ref SB138 Quik explorer throttle bracket issue 1

SERVICE BULLETIN NUMBER 138, ISSUE 1.

Quik Explorer foot throttle bracket
P&M Aviation have classified this bulletin as advisory.
Inspection before further flight.
Quik range with Explorer forks and Black Max wheels.

Fig 1. Throttle cable bracket (top right) modified with bottom corner cut off to miss throttle stop plate (on the left). Note wirelocking of throttle ferrule.

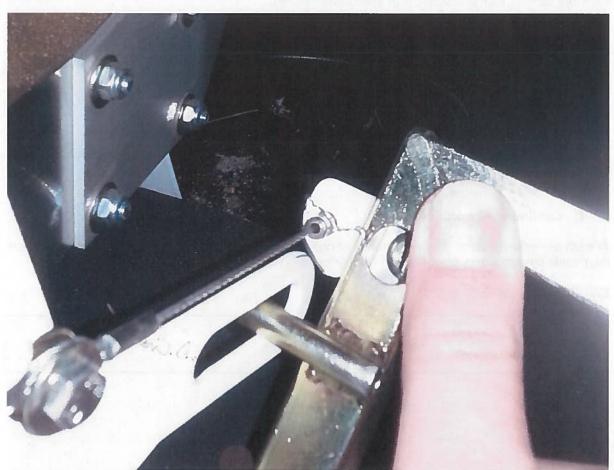
The Quik trike with "Explorer" front forks (identifiable by spun 6" aluminium wheels, NOT the white spoked 8" type) has a small bracket fitted to the throttle pedal which carries the throttle cable outer. Some examples have shown it possible for this small bracket to foul the throttle stop plate, preventing the throttle returning.

Operate the foot throttle over its full range and observe the minimum clearance between the stop plate and the throttle cable bracket as shown above. If the clearance is less than 2mm then the bracket must be replaced with part ZMS-362 rev.B (Modification M291) as follows:

- a) Undo the bolt and bush holding the throttle cable inner.
- b) Remove the throttle cable by pulling it through the bracket.
- c) Unbolt and remove the throttle cable bracket.
- d) Replace the throttle cable bracket with a modified one part no....
- e) Refit the throttle cable, secure the inner with the bolt.
- f) Wirelock the cable outer to the cable bracket.
